**Re: Pacific Northern Gas Ltd. and Pacific Northern Gas (N.E.) Ltd.
Application for Acceptance of 2019 Consolidated Resource Plan and for Acceptance of
Energy Conservation and Innovation (ECI) Portfolio Funding for 2020 and 2022
Response to BCUC Information Request No. 1**

**Pacific Northern Gas Ltd. and Pacific Northern Gas (N.E.) Ltd.
Application for Acceptance of 2019 Consolidated Resource Plan and for Acceptance of
Energy Conservation and Innovation (ECI) Portfolio Funding for 2020 to 2022**

**INFORMATION REQUEST NO. 1 TO
PACIFIC NORTHERN GAS LTD. AND PACIFIC NORTHERN GAS (N.E.) LTD.**

Figure 64: Forecast Gross and Net Annual Demand (TJ)

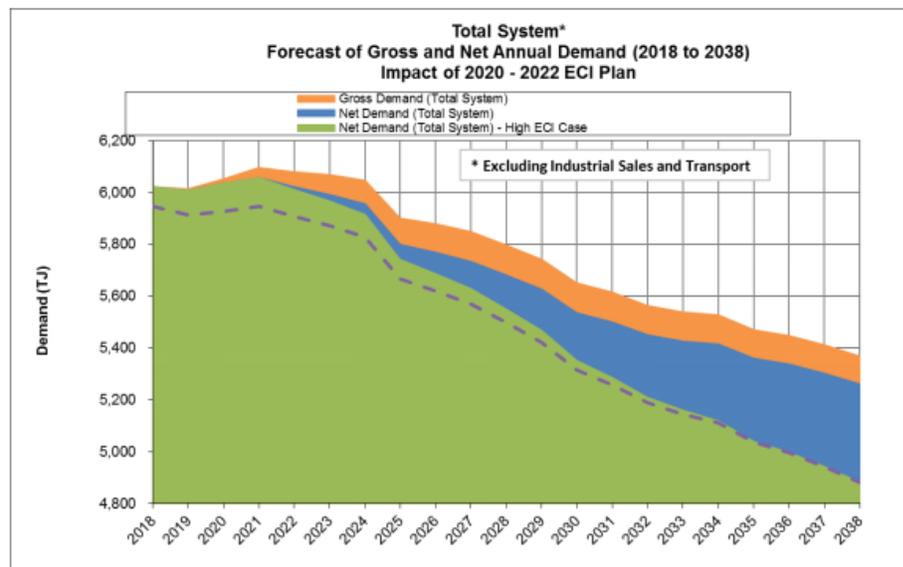
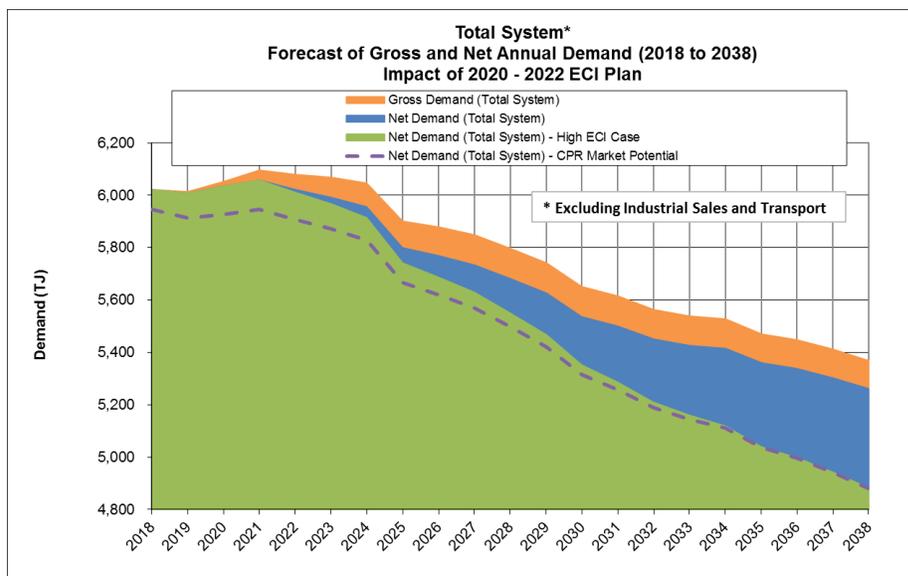
36.1 Please clarify the purpose of the dashed line on Figure 64.

Please see the revised version of Figure 64, below. PNG has corrected the formatting error in Figure 64. The dashed purple line indicates the total net system demand if the market potential savings identified in the 2017 Conservation Potential Review were realized.

For the purpose of the analysis presented in Figure 64, p. 131 of the Application, PNG estimates that the measures proposed in the 2020 – 2022 DSM Plan will be extended beyond the requested funding period and that these measures are estimated to reach market saturation in a further five years. PNG fully expects to continue to expand its ECI portfolio of programs and associated measures and expects to attain savings that are in addition to those forecast as presented in Figure 64.

Figure 11: AECO-C Natural Gas Price Forecasts

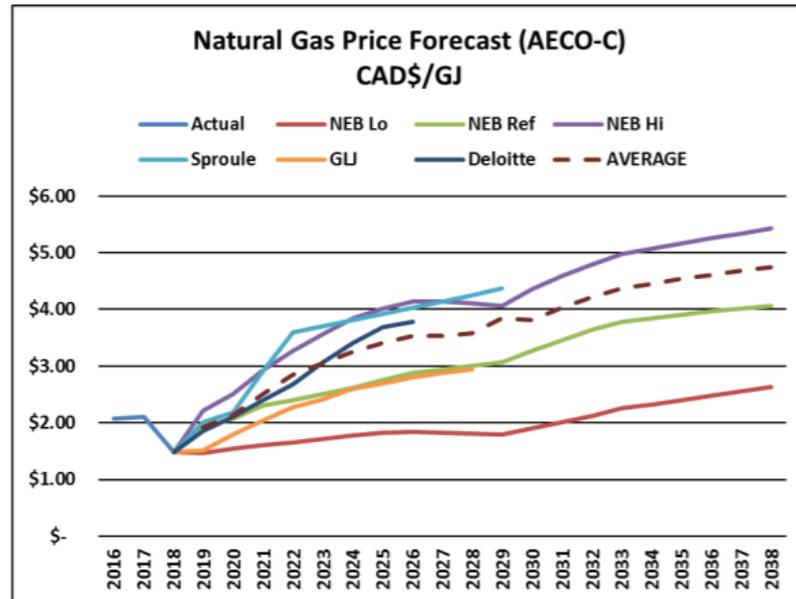
- 40.4 Please update Figure 11 to include Station 2 prices, based on the same NEB and industry forecasts.
